W-6 UPPER SEGMENT: HWY 90 TO SW MILITARY DRIVE SEWER MAIN PROJECT

Solicitation Number: CO-00317

Job No.: 19-4519

ADDENDUM 1

DATE:	SAWS PROJECT NO.	SHEET NO.
FEBRUARY 2020		S8
DESIGN:	KHA PROJECT NO.	
CD		
DRAWN:	068665052	
LAS		
CHECKED:		
MK

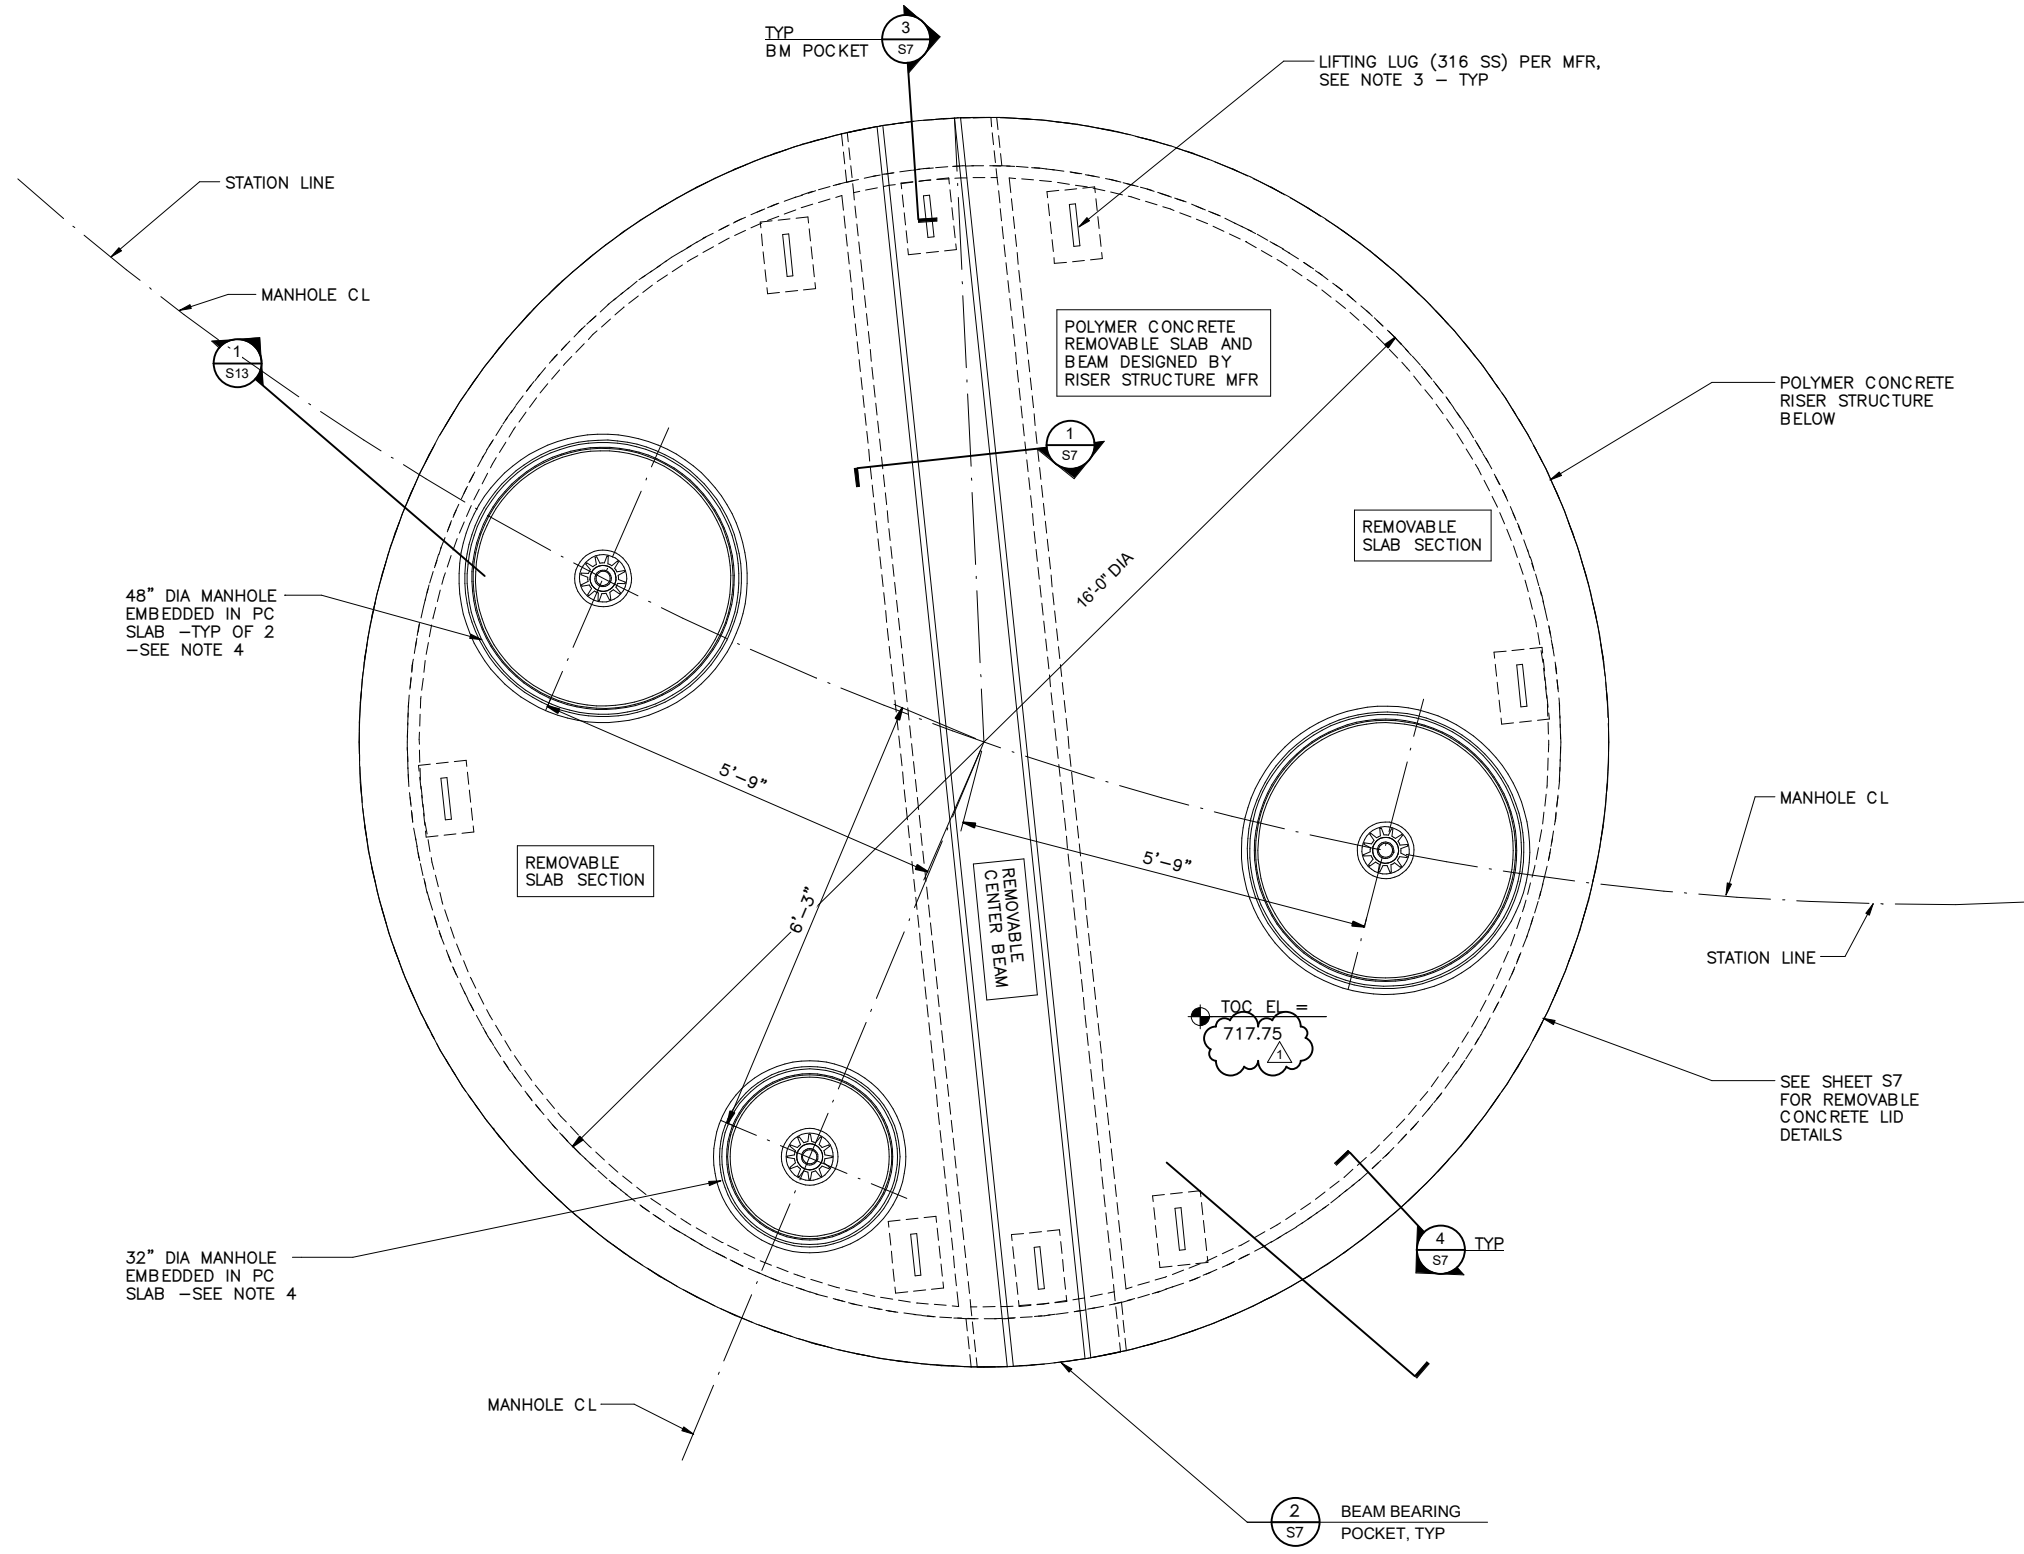
- Sheets S8 – STRUTURAL TYPICAL DETAISL VI - Revise and replace sheet in its entirety.
 - Detail 2- Revise callouts for the pipe coupling detail as shown.

PLOTTED BY: JAS
 DWG NAME: S12.SVD
 3/20/20 10:03 AM
 C:\Users\jsho\OneDrive\Bentley\Bentley Project\4190055\SAWS W-6 - RVT2 - jsho\jsho.dwg

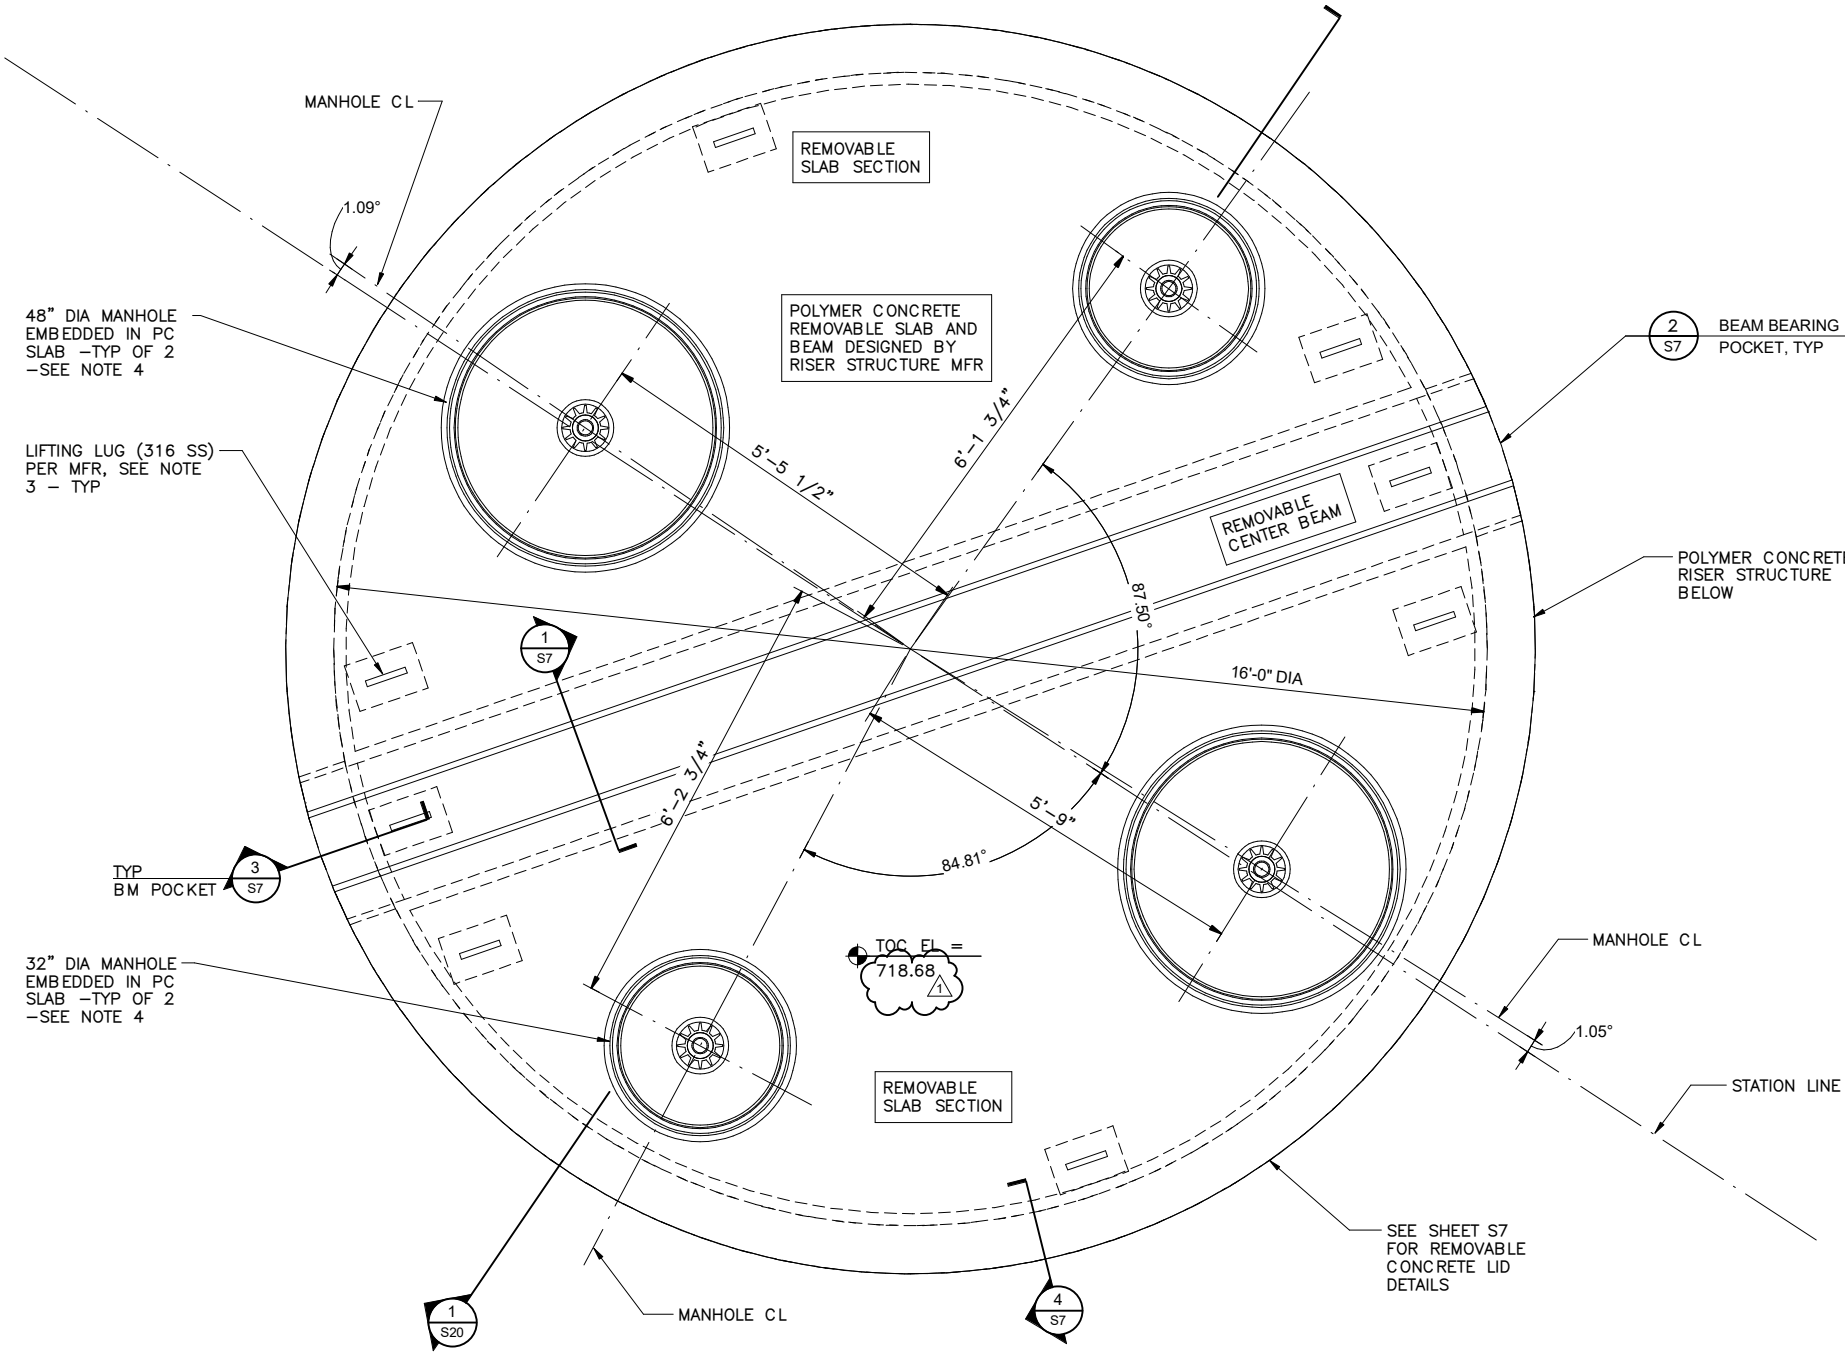
- Sheet S12 - SHAFT #2 (PEARSALL SHAFT) - UPPER LEVEL SLAB PLAN AT EL 717.56' - Revise and replace sheet in its entirety.
 - Revise Elevation callouts “EL 717.56” with the following: “EL 717.75” at three locations.

PLOTTED BY: JENNY L. JENKINS
 DWG NAME: S19.SVD
 3/20/20 10:03 AM
 C:\Users\jenkins\Documents\Drawings\2020\4190055\SAWS W-6 - RVT2 - jenkins@iqeng.com.rvt

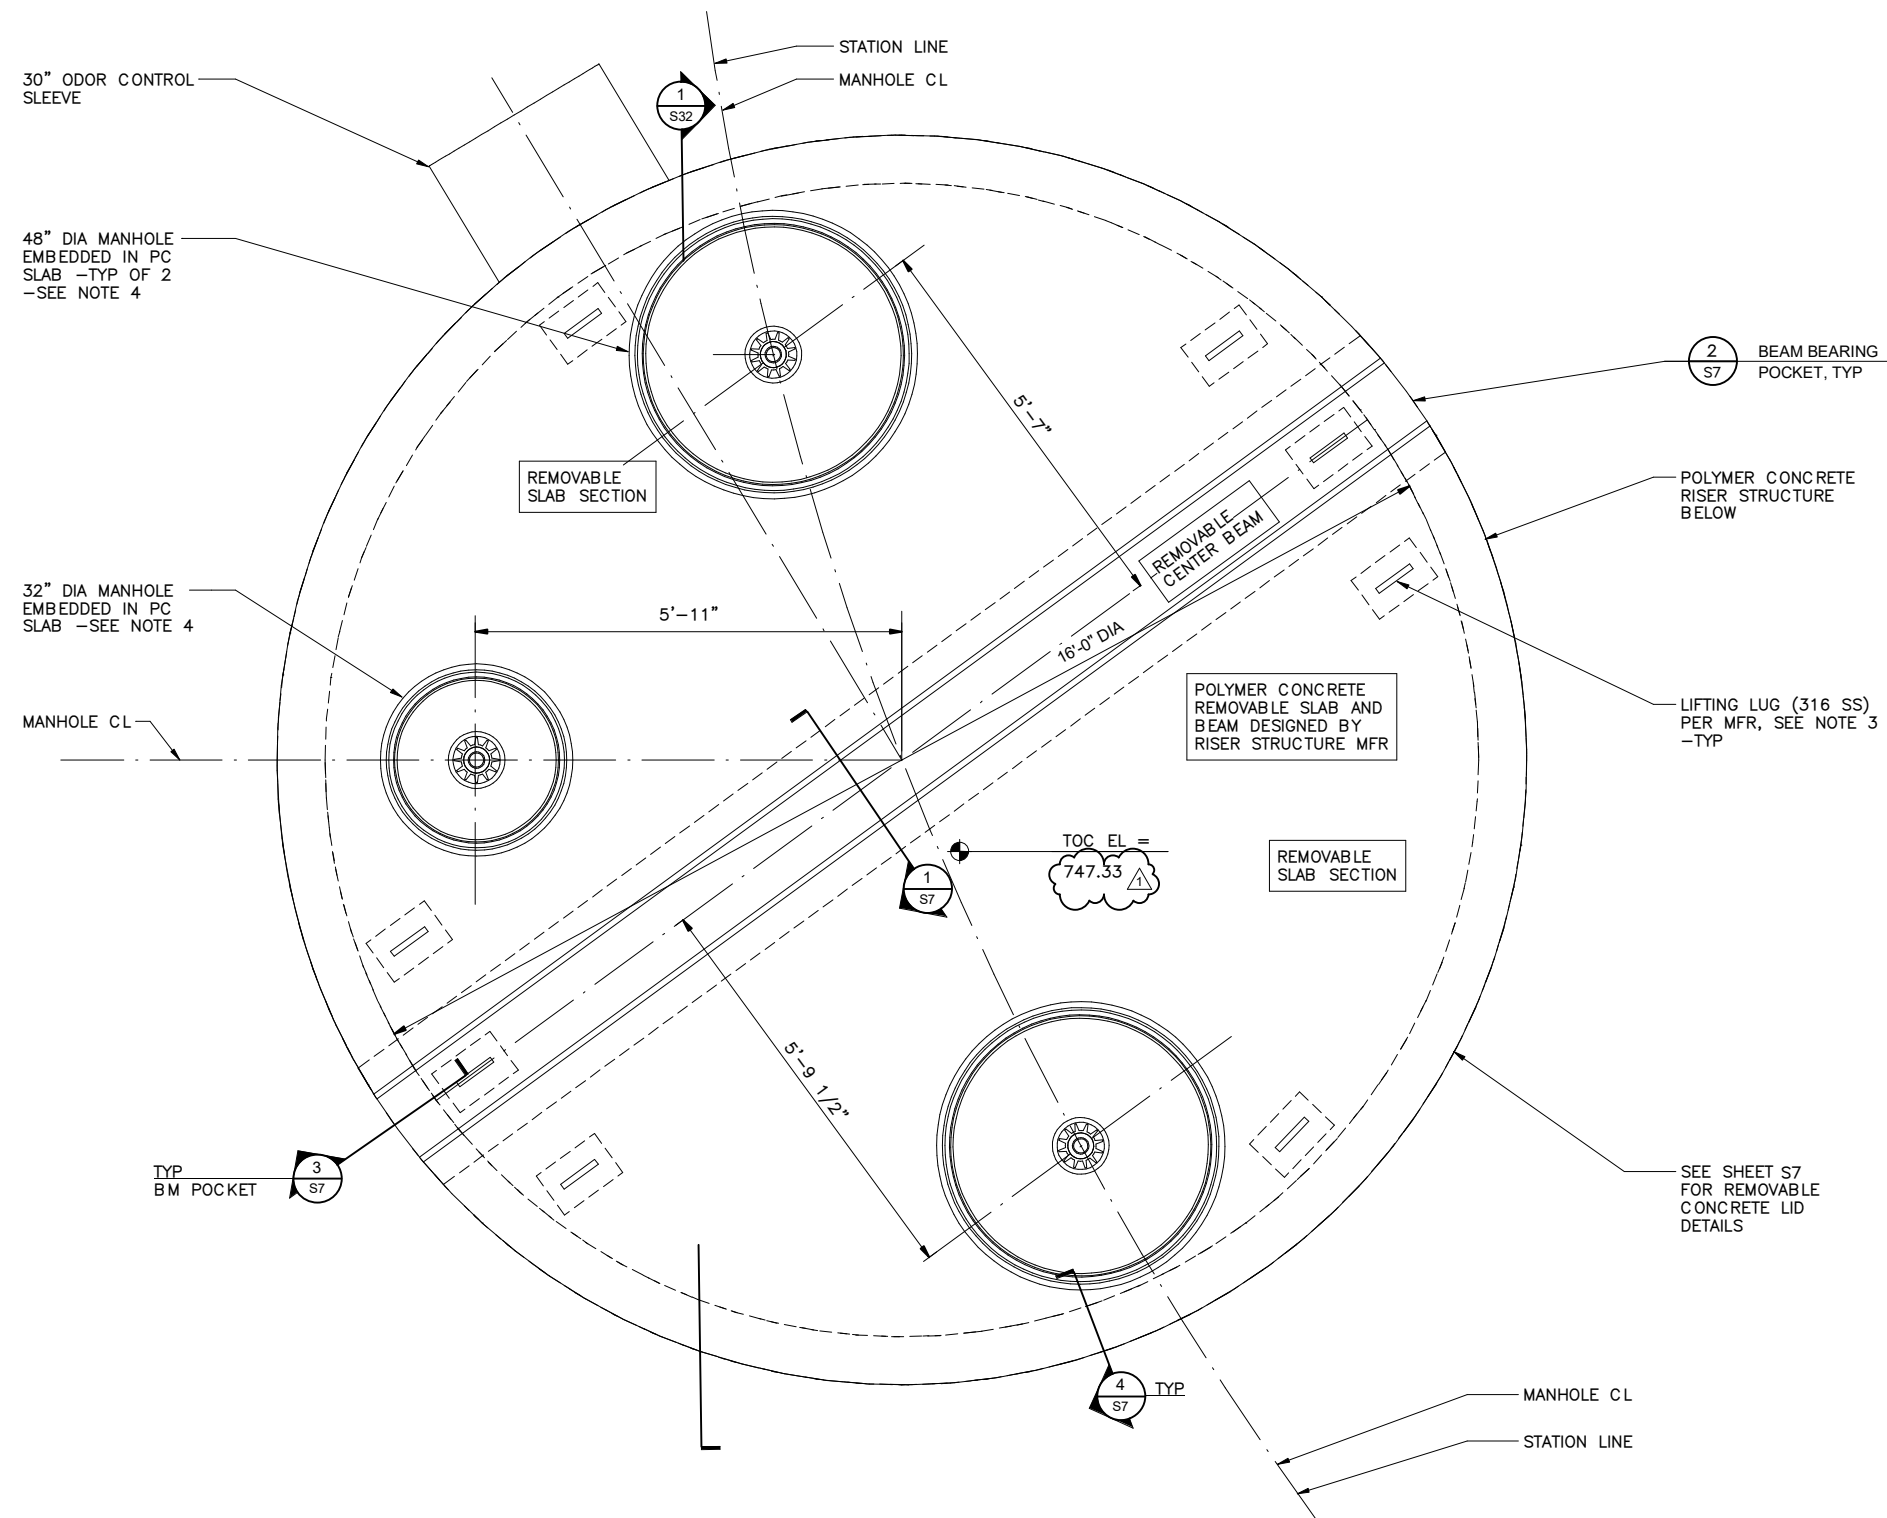
- Sheet S19 - SHAFT #3 (MERRY OAKS SHAFT) - UPPER LEVEL SLAB PLAN AT EL 718.20' - Revise and replace sheet in its entirety.
 - Revise Elevation callouts “EL 718.20” with the following: “EL 718.68” at three locations
